COUNCILLOR OBJECTION, MS COMMENTS & PETITION

APPLICATION No. **20/01515/MJR** APPLICATION DATE: 04/08/2020

LOCATION: LAND TO THE NORTH WEST OF WHITCHURCH HOSPITAL, PARK ROAD, WHITCHURCH, CARDIFF

PROPOSAL: PARTIAL DISCHARGE OF CONDITIONS 17 (CONSTRUCTION ENVIRONMENT MANAGEMENT PLAN), DISCHARGE OF CONDITIONS 10 (HIGHWAY AND PEDESTRIAN WORKS DETAILS), 13 (BRIDGE FINISHES), AND 14 (SOIL RESOURCE SURVEY (ACCESS AND ENABLING WORKS)) OF 17/01735/MJR

Figure 1.1: Enabling Works

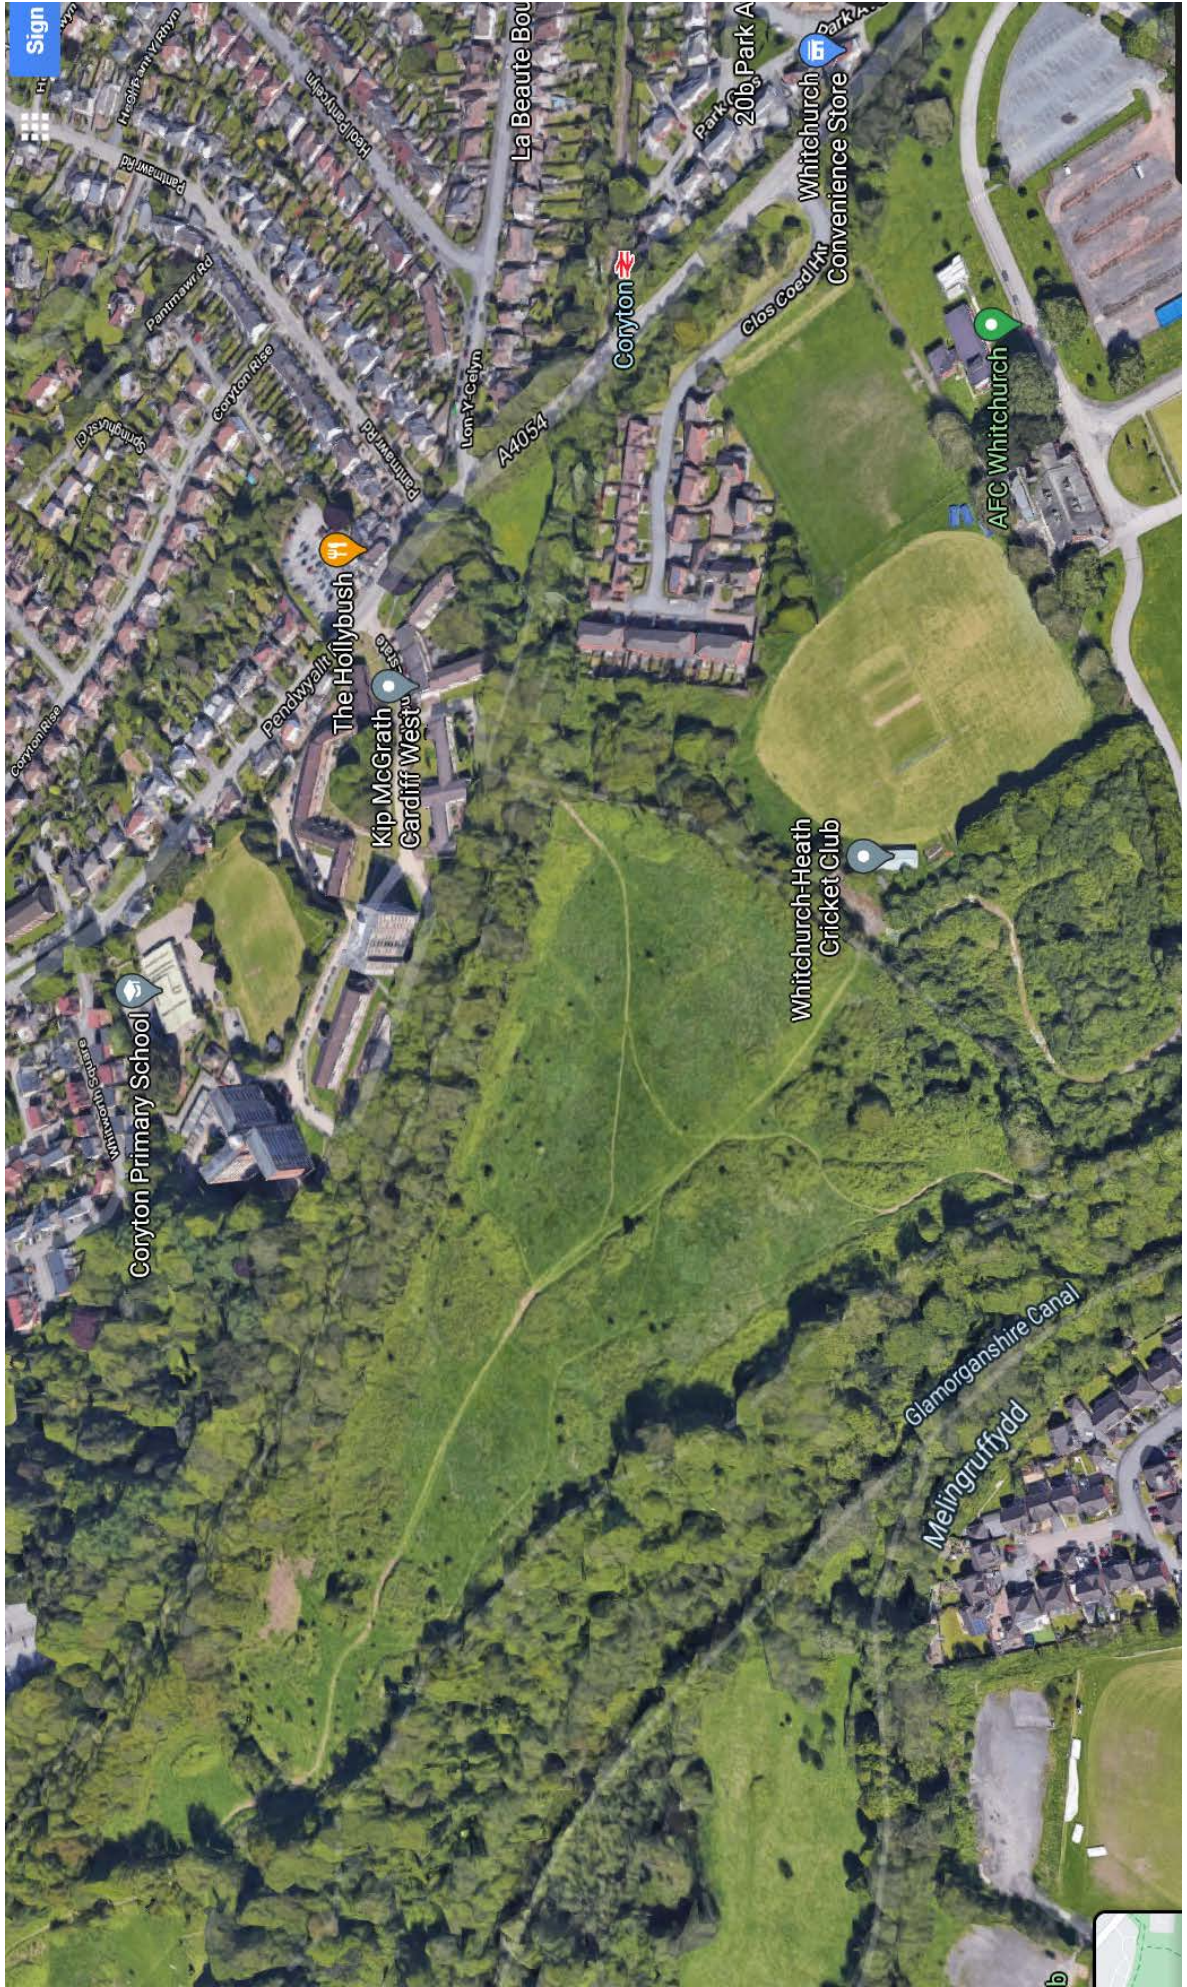
Condition 17: Construction Environment Management Plan (CEMP) We note the application seeks partial discharge of condition 17. We understand this application relates only to the 'enabling works' which are indicated under Figure 1.1: Enabling Works and described under 1.3: Implementation Programme in the CEMP (prepared by Mott MacDonald dated October 2020 Revision D).

CONDITION 10

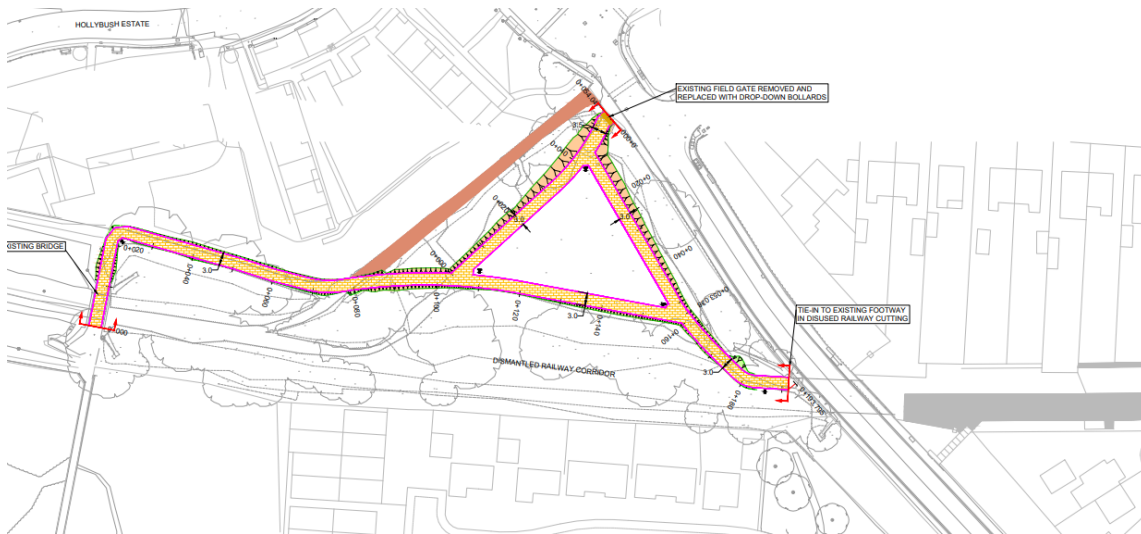
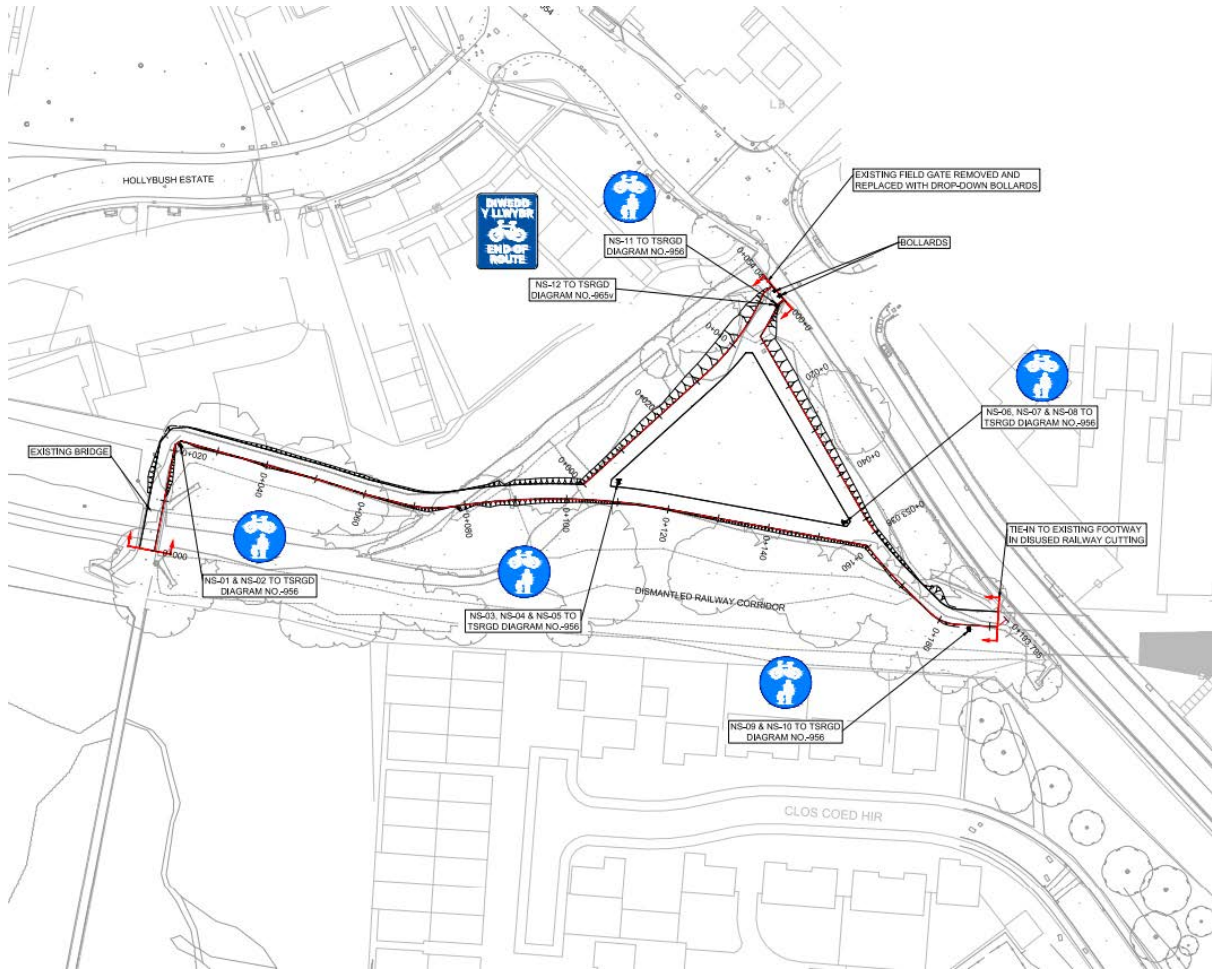
Objectors contend (Petition Technical Objections submission) that Condition 10 is not satisfied inasmuch as the wording requires details of a ‘...pedestrian and cycle connection...’ to be submitted, and that as the submission does not include a cycle connection the condition cannot be discharged.

However, whilst I agree the description and title of the plans do not specifically reference cycling (referring as they do to pedestrian paths), it is clear from the drawings themselves that the intention is to provide shared pedestrian and cycle paths throughout. If we look at the submitted plans the width of the path is identified as 3m (the minimum for shared width path), and the ‘Traffic Signs and Road Markings’ plan (70066877-WSP-XX-XX-DR-CE-P3-1 rev P01) clearly indicates an intention to install shared cycle route signage. I must therefore conclude that the omission of the words cycle/cycling from the description is an oversight by the designer.

In considering what would be appropriate in terms of the path and any cycle facility, we must take into account the size and nature of the Lady Cory Field, and the impact the path would have on that setting. We must also consider what existing facilities the new path will connect with, in this case a rail station and Park Road to the east, and the Cancer Centre development to the west. Taking all the factors into account it is felt that it would be out of proportion to implement a fully segregated cycle facility that would involve the creation of a path with an overall width of some 5m for a length of less than 200m. In which respect it is noted that the proposed path does not tie into a segregated cycle facility at either

end and as such would represent an isolated stretch out of character with its surroundings.

I am therefore content that the submission in connection with Condition 10 is sufficiently comprehensive to agree discharge of the same

CONDITION 13 (ASDA)

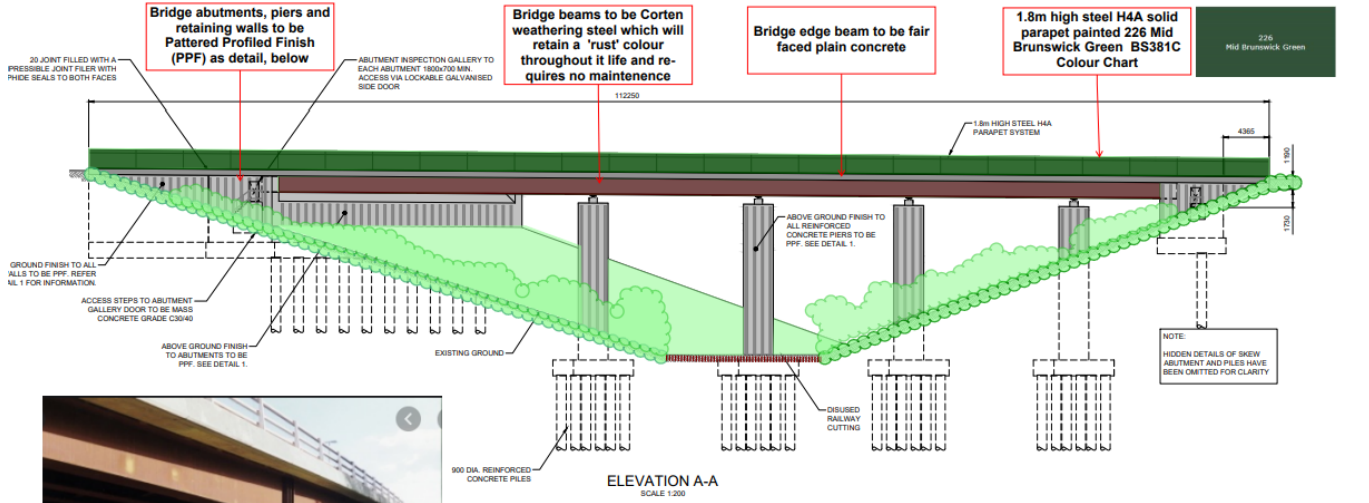
- The Emergency Bridge abutments not same design as main bridge? Keeping the same design will minimise the impact on local environment?
- The abutments of the main bridge are individual columns, not wall. They are in line with cutting not at an angle to it. Making both same and minimise visual impact.

- The main bridges have H4A containments to solid parapets with 1.8M high metal coverings. As the main bridge will have low traffic and a cycle/pedestrian path to one side, and the emergency bridge has no traffic why are these considered necessary? A lower and open parapet would lessen the impact and improve the visual experience for users

The pillars would be finished in pattered profiled finished concrete with the bridge beams finished in corten steel, which retains a rust colour. The 1.8 metre high steel parapet wall would be finished is a mid Brunwisck Green.
